ARM PrimeCell®  
SRAM NOR + NAND Flash Memory Controller (PL353)  
**Errata Notice**

This document contains all errata known at the date of issue in releases up to and including revision r2p1 of SRAM NOR + NAND Flash Memory Ctlr -3YT

**501623: CS not deasserted in accesses to NAND in certain modes of operation****Status**

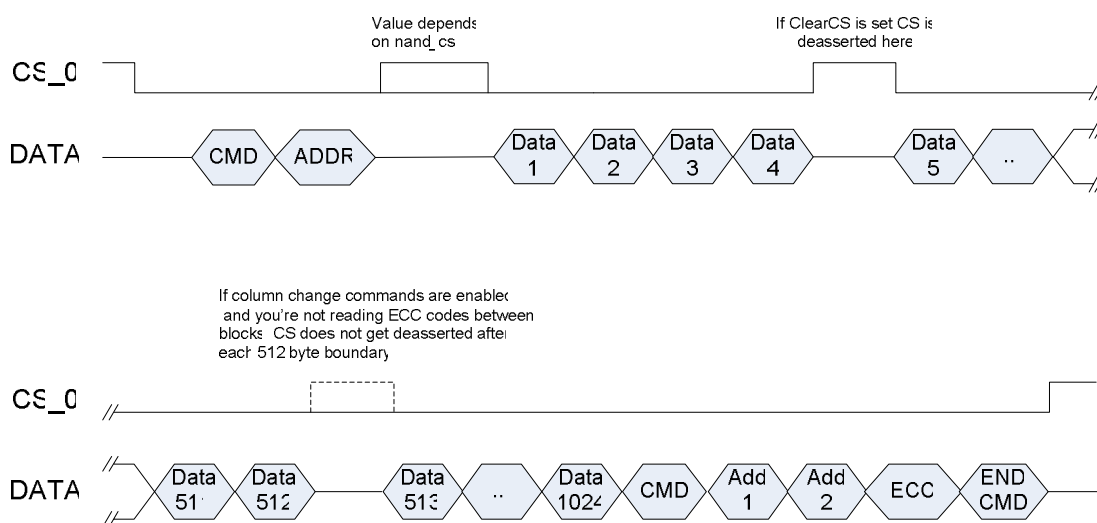
PL351/353 is designed to support NAND devices that require **CS** to be held low between data-phase accesses, as well as devices that do not have this requirement. To satisfy both types of memory the ECC block will not deassert **CS** after a block has been completed if it is about to issue a command.

However, in certain modes of operation (specifically when column-change commands are enabled and you are not reading ECC codes between blocks), PL351/353 incorrectly assumes that it is about to perform an operation and cancels the request to ClearCS.

This results in **CS** not being deasserted after the last transfer in a 512 byte block and while **CS** is deasserted the EBI will not be released. The following timing diagram illustrates the **CS** behaviour.

Under the above mentioned conditions, **CS** will not be deasserted. This could result in a deadlock situation if data or code required to create the next transaction is stored through the same EBI.

If ECC is disabled, this problem will not occur.

When using ECC, there are two possible work arounds:

1. Use the ECC block in full command mode for writes, and read ECC codes between blocks for reads.

2. If you are reading or writing more than one 512 byte block, ensure that the data crosses the 512 byte boundary in a single un-interrupted transaction.
